VKPA 83650

Technical Bulletin - April 2010

OE/SKF DESIGN EVOLUTION
VKPC 83650 is replaced by VKPA 83650

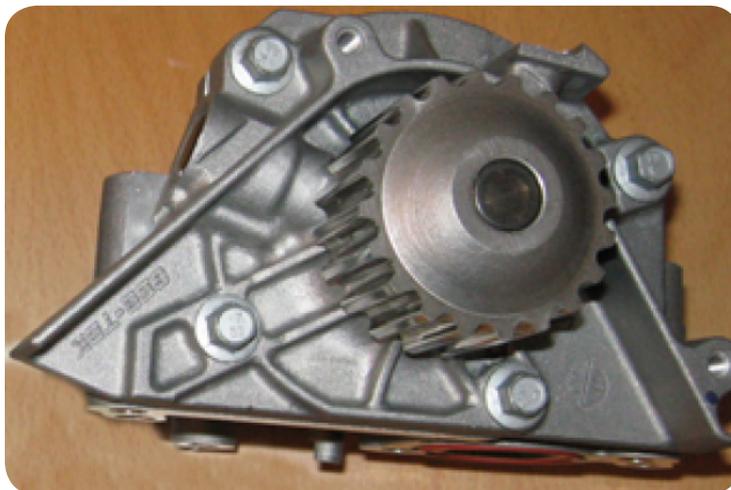
PSA/Fiat have changed and standardized the design of their Water pump allowing the fitting to all applications ⇒ SKF part number: VKPA 83650.

Some old engines design are using a plastic backhouse/water pump which has been replaced by a complete cast metal water pump (referring/replacing the previous TB VKPC 83650).

- VKPC 83650 is replaced by VKPA 83650 (Water pump + backhouse)

New location for the fixing holes.

The old backhouse design (whether plastic or aluminium) has to be completely replaced by our VKPA 83650.
